STAFF REPORT

CITY OF HUBBARD PLANNING COMMISSION

FILE No.: Site Development Review, file #DR 2022-02

REQUEST: Site Development Review approval for two abutting properties. Address 2363 is developed with an existing 15,000 SF office/warehouse building, a 12,600 SF warehouse building, parking, landscaping, and outdoor storage area. Address 2347 is a vacant undeveloped field. Applicant proposes to develop a fenced gravel yard on 2347 for outdoor storage of electrical materials and equipment, in support of an electrical supply warehouse and distribution company occupying both lots.

COVER SHEET & INDEX

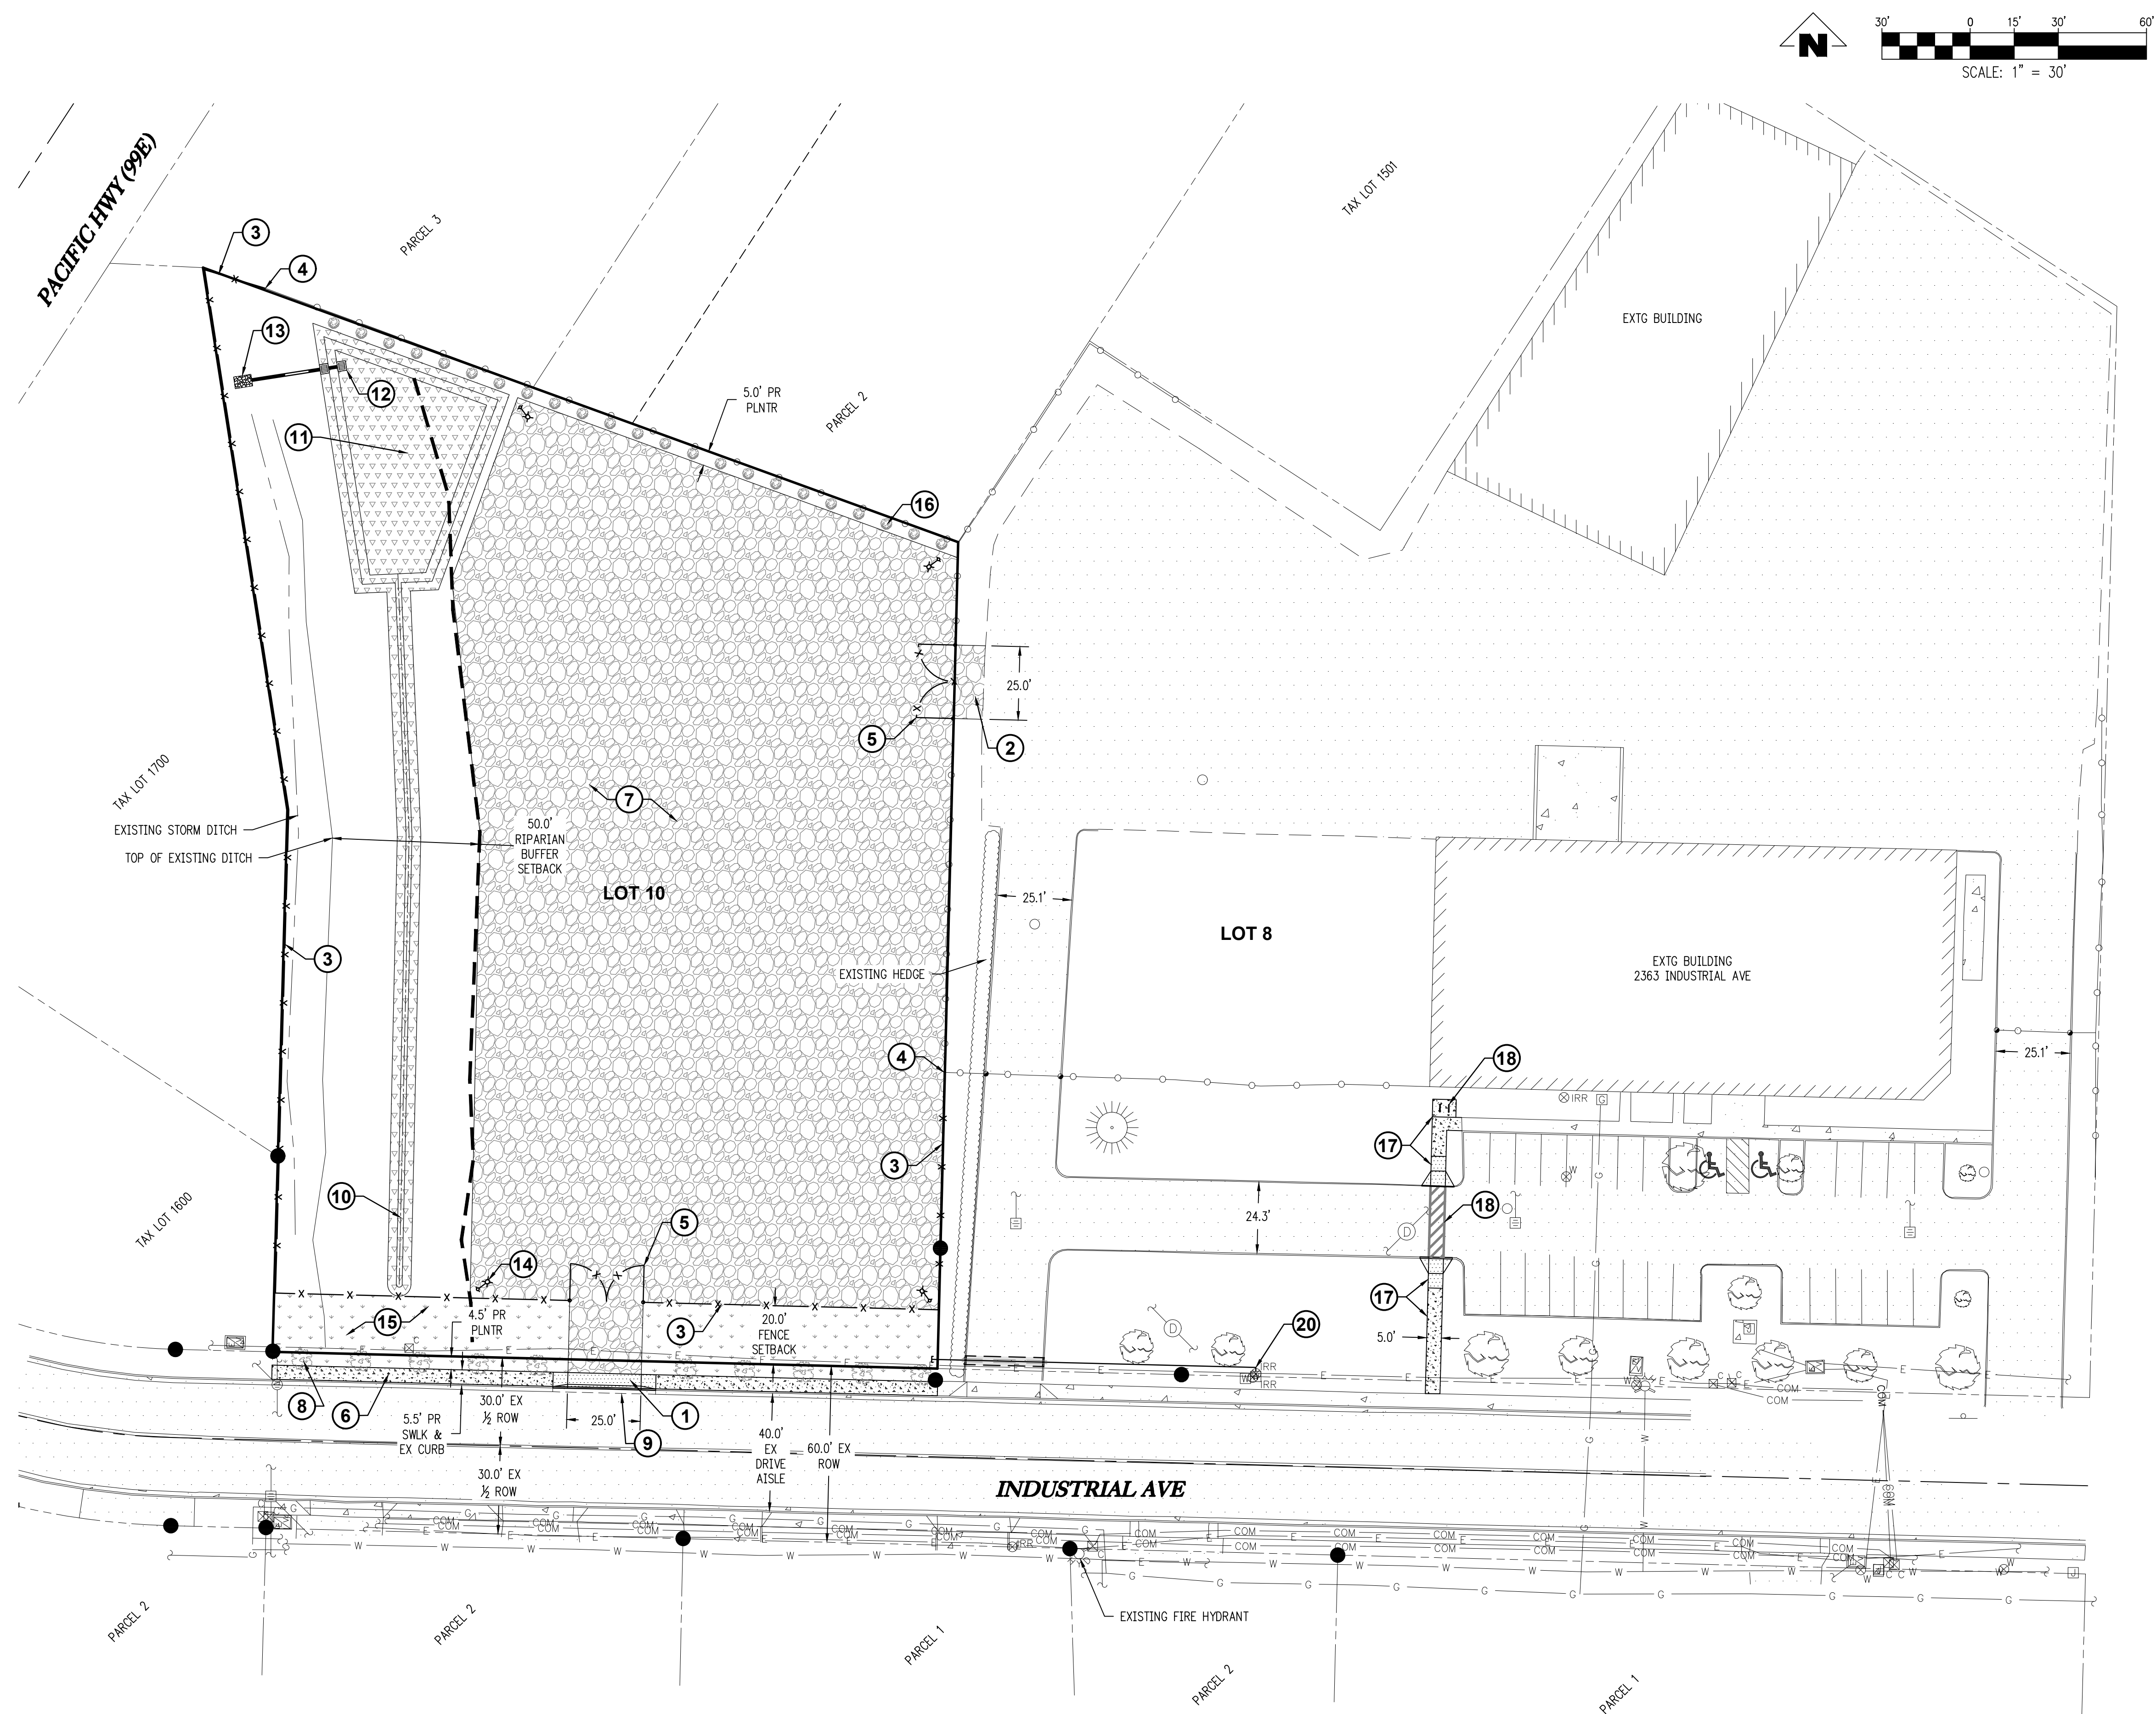
- Staff is correct, this is a typo.
- What is the total amount of landscaping provided in square feet on each lot, TL 1300 and TL 1500?
 - Site data table on sheet 1 is updated to address this question
